Comments on "THE RANCH" from Judy von Ahlefeldt per the plan revision after Meeting 1 presented in March, 2019.

Falcon -peyton
 Plan composite Map
 from Chapter 4 with
 present planned BG/S
 Overlay and Banning
 Lewis Parkway.
 Green dotted line is
 edge of BF Plan along
 Sand Creek tributary

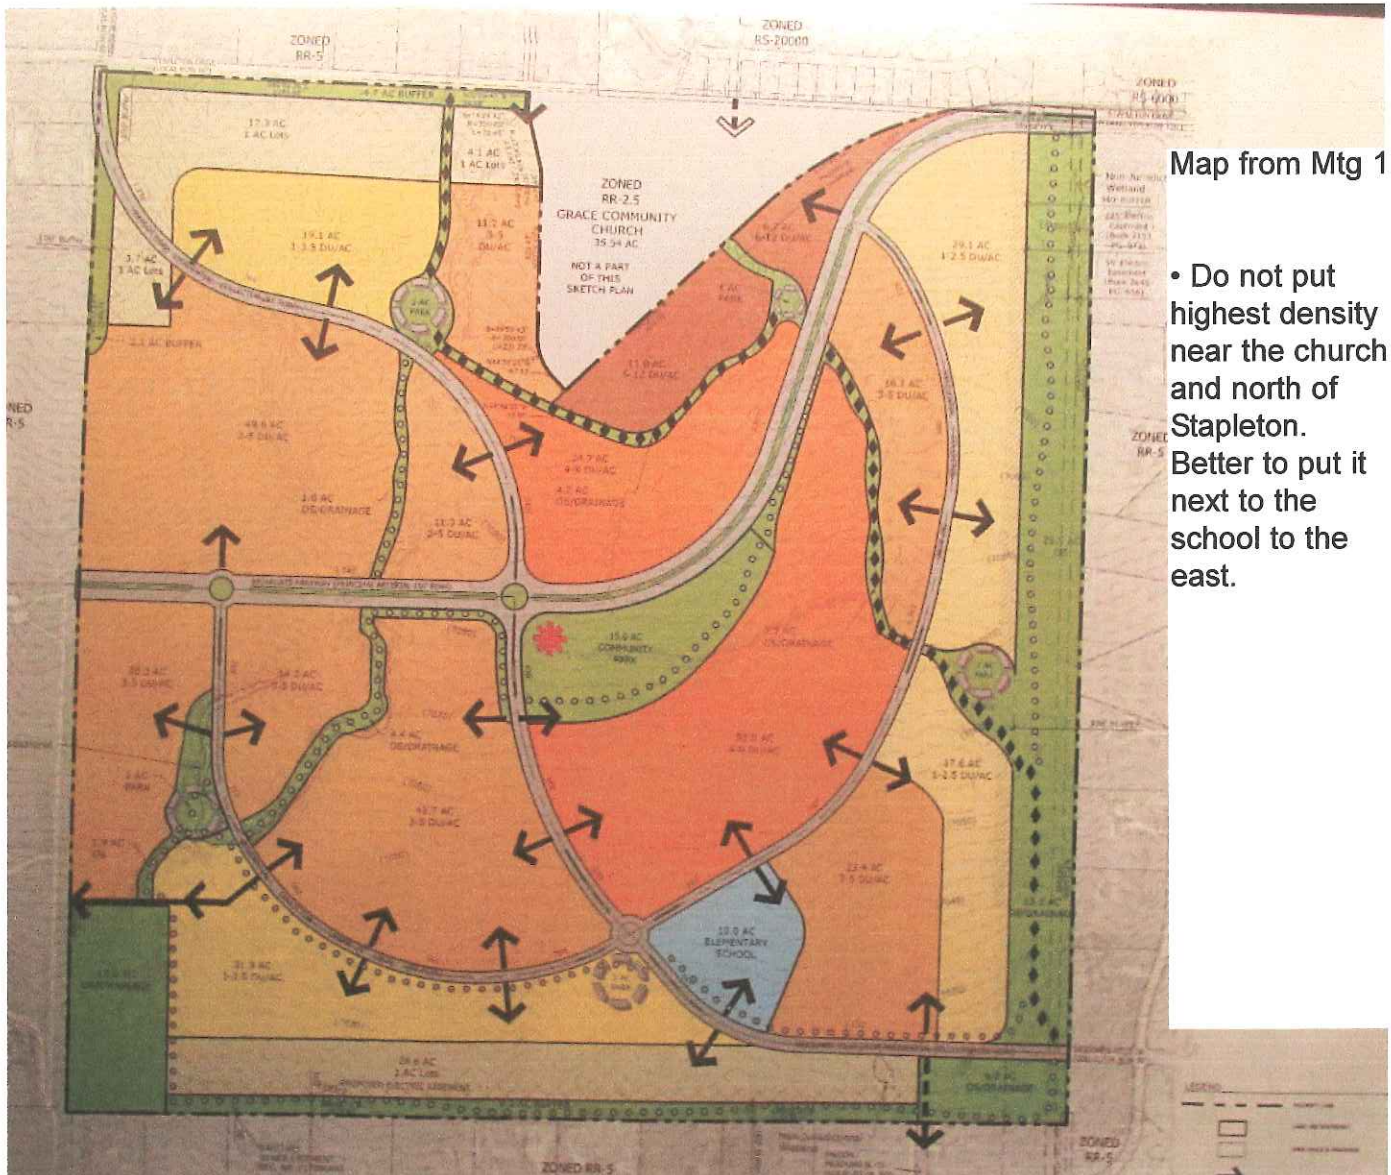
- Please note that over 3/4 of this project is in Subarea 10 of the *Black Forest Preservation Plan*.
- Stapleton and ^Banning Lewis Parkway should ^{be} be put in at least as two-lane roads before this subdivision is allowed to be built. Using existing local roads for construction and deferring building access to Vollmer and Woodmen is not acceptable and is damaging to existing neighborhoods.

- Note that the intent of interaction among the BF Pres Plan and the major E-W Corridor (Stapleton) is to allow Stapleton to essentially act as the boundary for urban development expected from the south, and to allow campus-like and commercial uses for 1/4 mile immediately north of the this corridor and then begin a rapid transition to 5 ac tracts at the trees, Where existing 5 acre uses are in the prairie, a generous open space buffer is recommended - more on the order of 300', not 50 or 100'- about the width of the Excel power line ROW.

- Subarea 10 of the BF PP calls for a emphasis of **TRANSITION** from urban to 5 ac tracts and respect of buffering (which needs to be on the project) of existing RR-5 zoned rural residential areas, while Subarea 9 calls for a "**BALANCED MIX**" of urban density uses. We are not seeing balanced mixes in current large-scale monolithic urban developments.

- Neither the Falcon or BF Pres Plan envisioned rural residential uses greater than RR-5 unless clustering was used as a tradeoff for more open space.
- Placement of urban density along major corridors was expected.

- Wall -to wall rooftops were not intended.
- The 1974 BFPP envisioned urban nodes with large lot and agricultural uses separating them (for example along Woodmen Road).

Map from Mtg 1

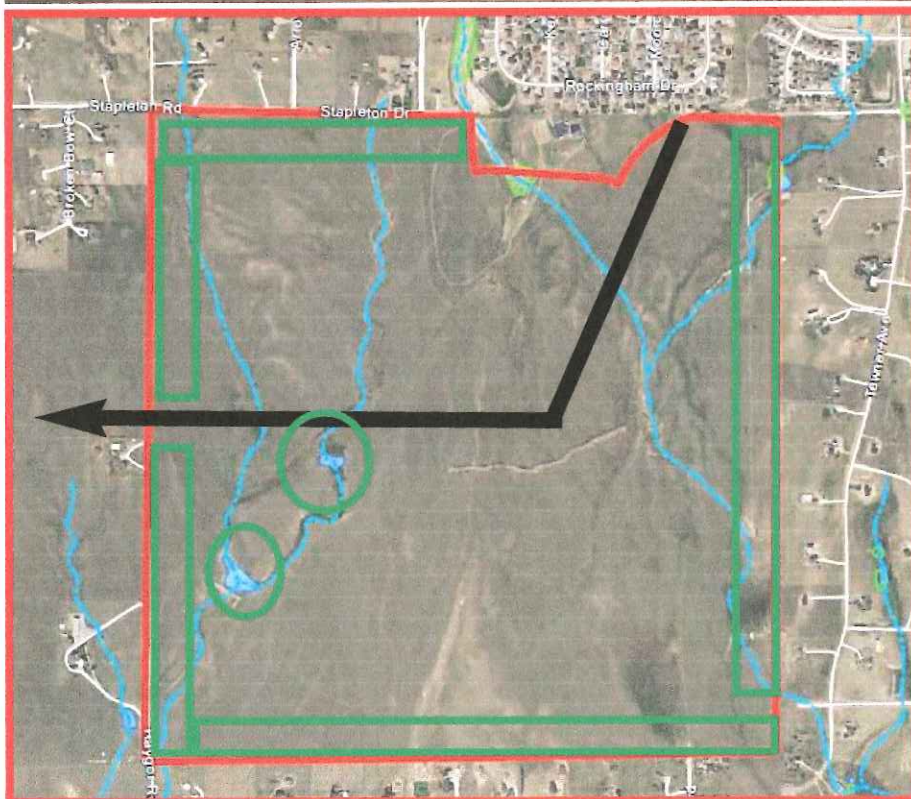
- Do not put highest density near the church and north of Stapleton. Better to put it next to the school to the east.

- Widen buffers (200') on N, west, south; 300' under Excel line on east
- Extend Bow Valley buffer to Stapleton on West; add buffer to south property line on West.
- Buffers provide transition, open space noise mitigation, room for antelope to move, and place for Prairie Necklace Trail is this subdivision.
- Widen area for internal trails along wetlands and restore those wetlands (willows and cottonwoods)
